Re: **Application for Construction Permit for a
New FM Station in Richwood, Ohio
(File No. 920115ME)**

AMENDMENT

The application is hereby amended to reflect a 3-kilowatt rather than a 6-kilowatt operation. The attached engineering materials prepared by John W. Dettison, the applicant's

EXHIBIT TWO
VERTICAL PLAN SKETCH
SHOWING PROPOSED ANTENNA
RICHWOOD, OHIO.

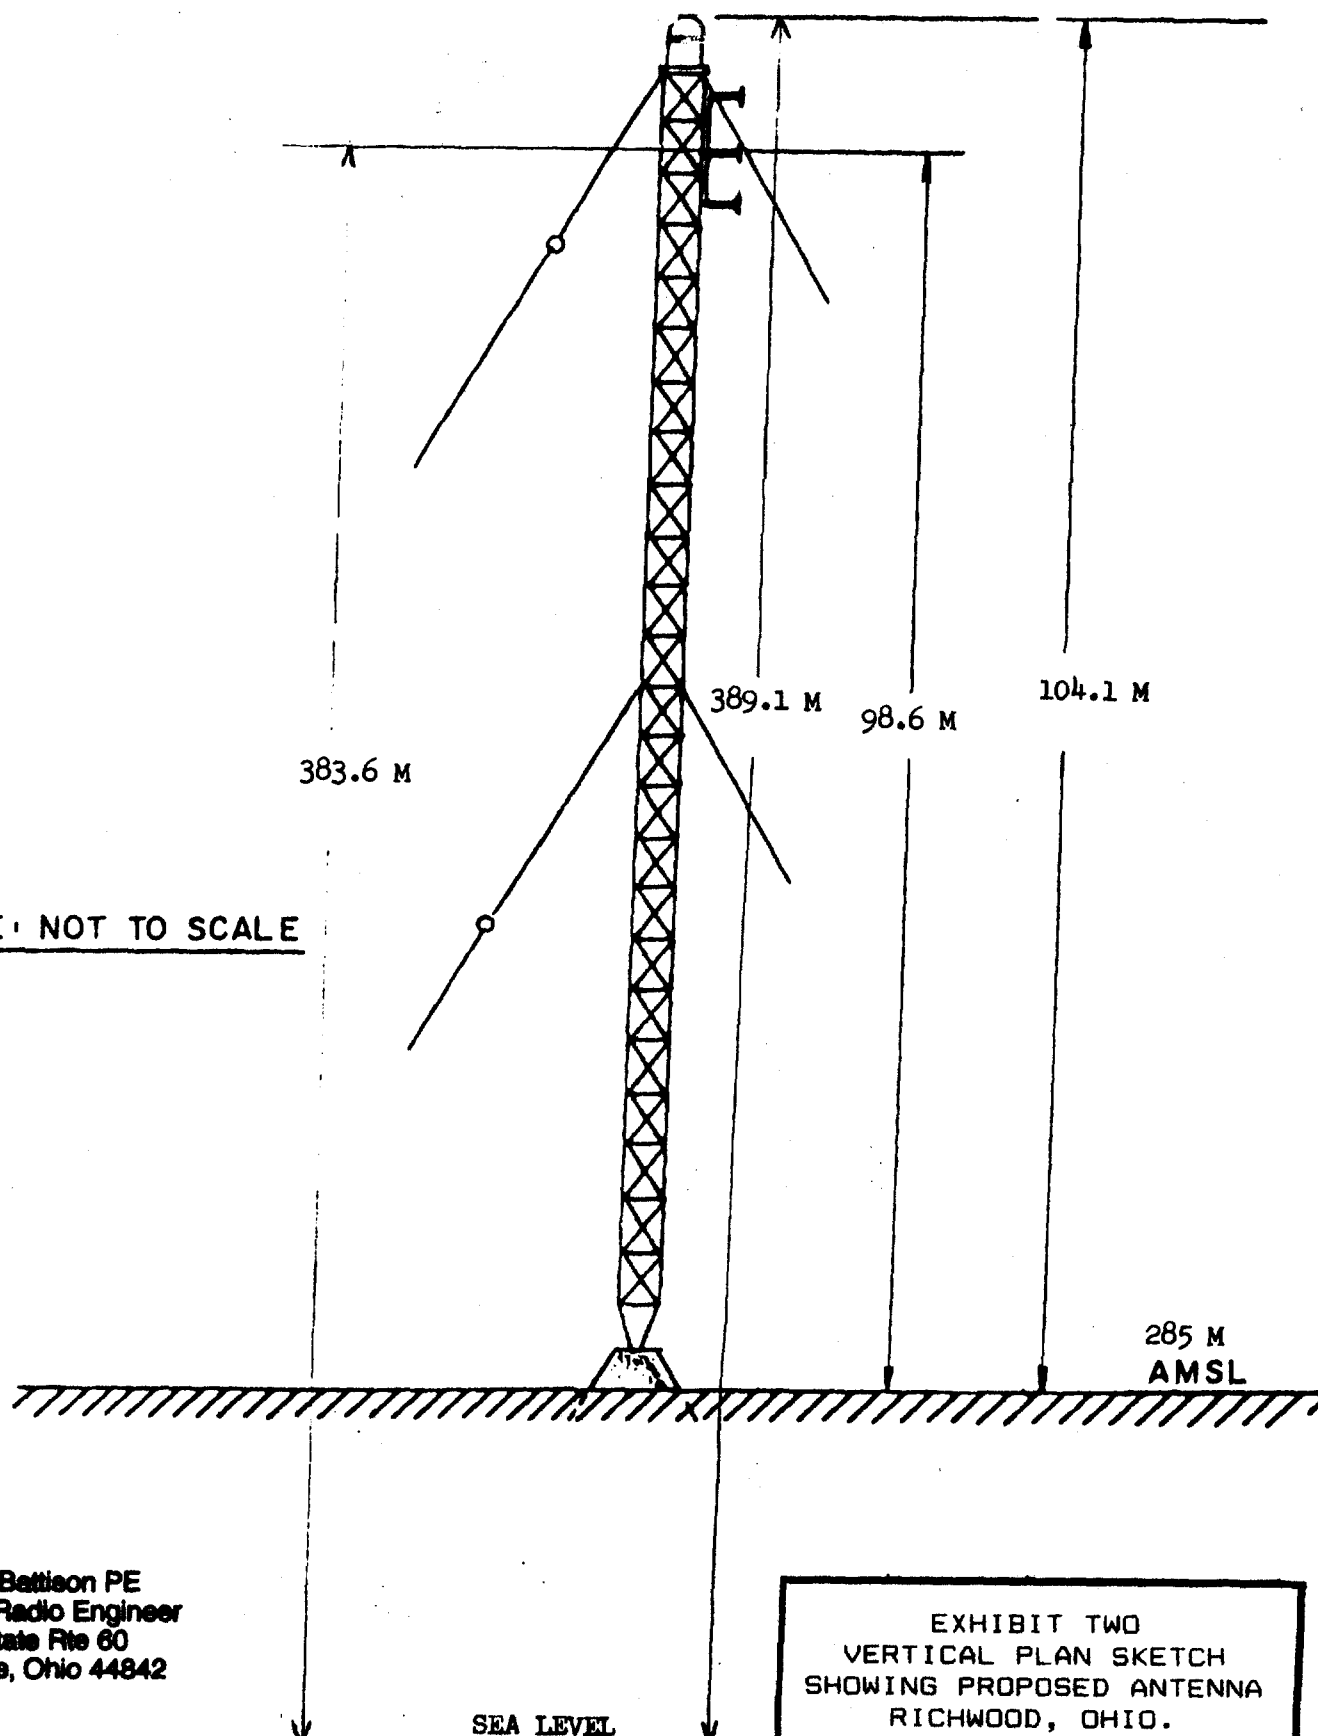
This original application was timely filed under the mistaken impression that the Commission had allocated channel 282A with a power of 6kW ERP. The Report and Order announcing the availability of the channel did not disclose the fact that only 3 kW was proposed. When the error was discovered this Amendment was prepared. The Amendment seeks to reduce the ERP to 3 kW, change the transmitter site, tower and antenna height and HAAT, and thus cure the defect.

It is proposed to relocate the transmitter on a new tower to be erected at 10540 Askins Rd. on the outskirts of Magnetic Springs, Ohio.

(2) of the top of supporting structure above ground (including antenna, all other appurtenances, and lighting, if any); and 104.1 meters

(1) above ground 98.6 meters (H)

Exhibit Two is vertical plan sketch of the tower
